LK35, LK35B and LK35L Models

Shop Drawing Submittal Review

Project Name: Webster University-**ISB**

SPEC SECTION: 22 4216.16
Commercial Sinks

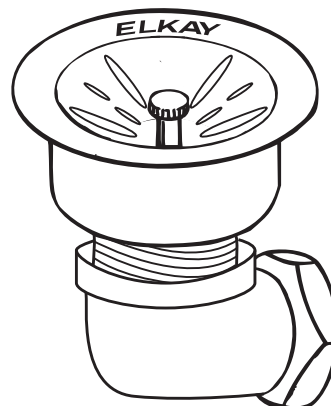
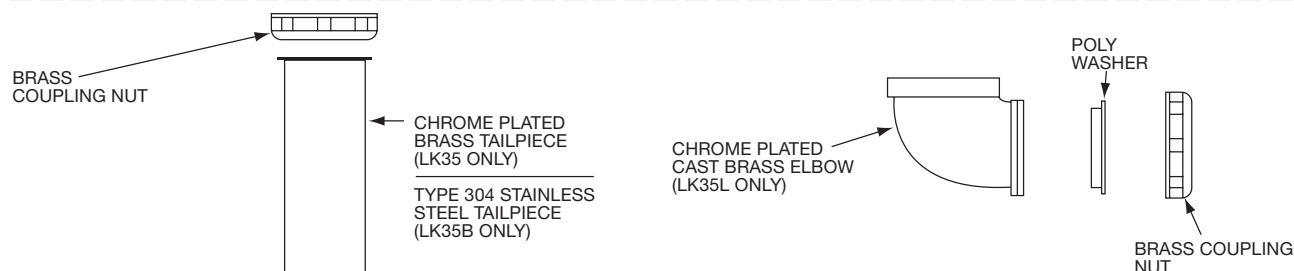
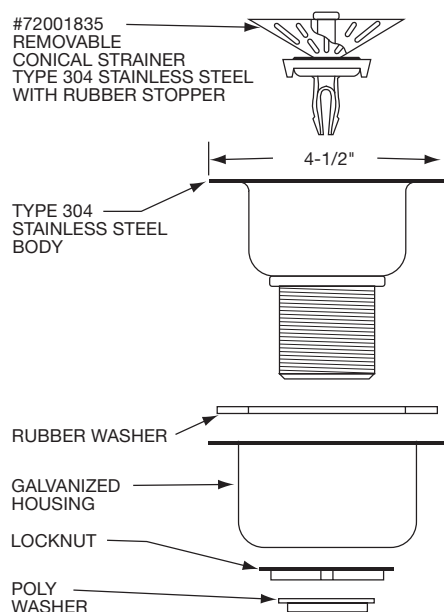
1. Provide under counter waste and supply protective piping covers as required.
Verify requirements with the architectural drawings.
2. Escutcheons are specified to be cast brass. Refer to specification section 220518.
